**ON-SITE SEWAGE DISPOSAL SYSTEM  
HOWARD COUNTY HEALTH DEPARTMENT  
BUREAU OF ENVIRONMENTAL HEALTH**

ADDRESS: 9454 Vollmerhausen Road PROPERTY OWNER: Richard Douse

SITE INSPECTION SHEETOWNER: Richard Douse PHONE #: \_\_\_\_\_ADDRESS: 9454 Vollmerhausen Rd CONTRACTOR: \_\_\_\_\_

PROPOSAL: Evaluation of existing septic system for proposed building permit to enlarge living space (No bedrooms)LOCATION DIAGRAM new

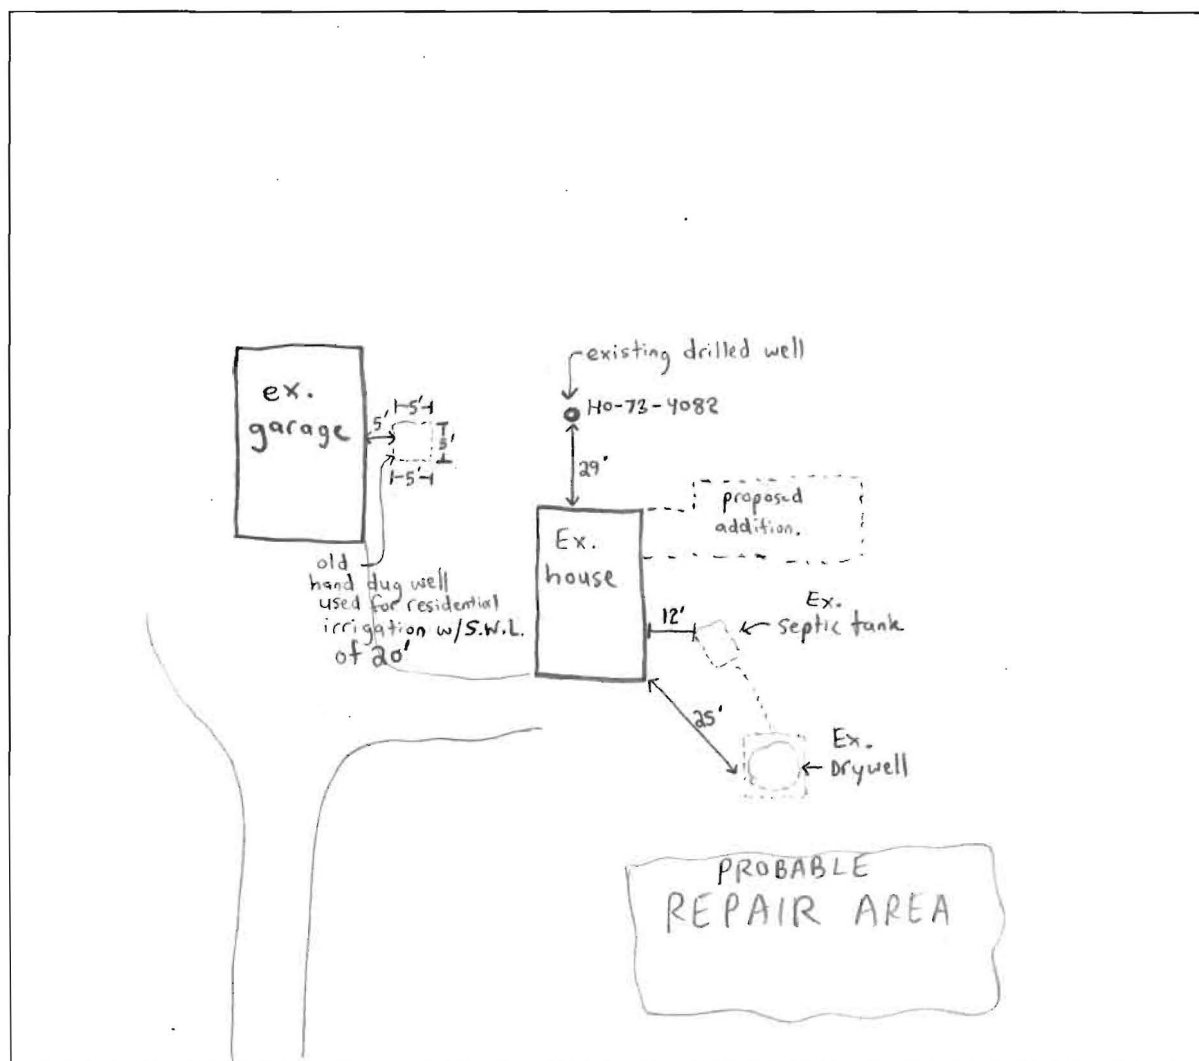
COMMENTS: Property is not in the metropolitan district for water or sewer, ex. system is functional. Opened drywell & septic tank, both appear to be in excellent condition despite system age. Drywell has only a few feet of effluent inside. Although suitable repair area exists,

↳ property will get hooked up to public water and sewer if ever sold.
